Mr. Daniel Sexton, Reviewing Planner
Land Use Review Division
City of Colorado Springs
RE: CPC MP 86-00520-A2MJ17

From: Ralph Braden <rbraden@nor-wood.com>
Sent: Thursday, January 26, 2017 10:25 AM
To: Sexton, Daniel; Carleo, Katie
Cc: Bobby Ingels; 'Jim Nass (jim@nassdesign.net)'; 'Kent Rockwell (kent@rockwellconsulting.net)'; Jeff Mark
Subject: Bradley Ranch. Comments of Nor'wood as owner of Wolf Ranch. 1.26.17
Attachments: FW Sorrento Development Plan; FW Sorrento-Wolf Ranch Wolf Ranch comments to development plan

Major Issues with the Bradley Ranch Proposal

FIGURE 4

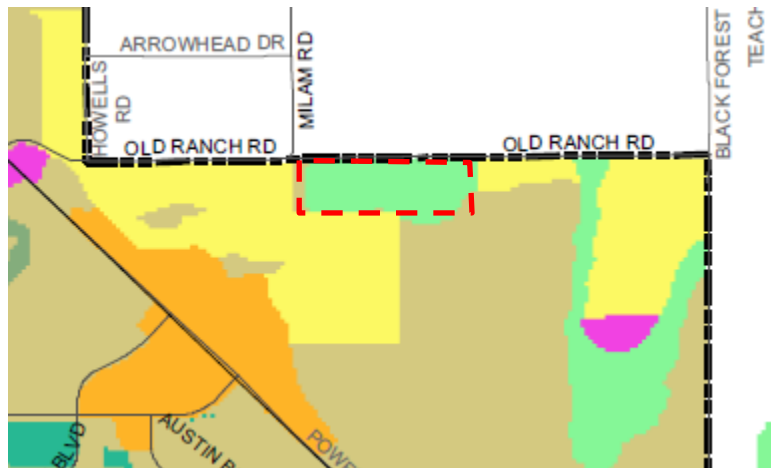
1. The site is identified on the 2020 Land Use map (approved by City Council on 12/14/2010) with a land use of "Candidate Open Space". See site outlined below.

2. Under #2 Development Plan Review Criteria, the 2020 Land Use Plan referred to is incorrect or not the most recently approved land use plan. The site is not identified as low density residential as noted above. Also, Cordera has followed 2020 Land Use Plan and has not proposed or approved High Density Residential in areas originally comprehensively planned as low density residential.
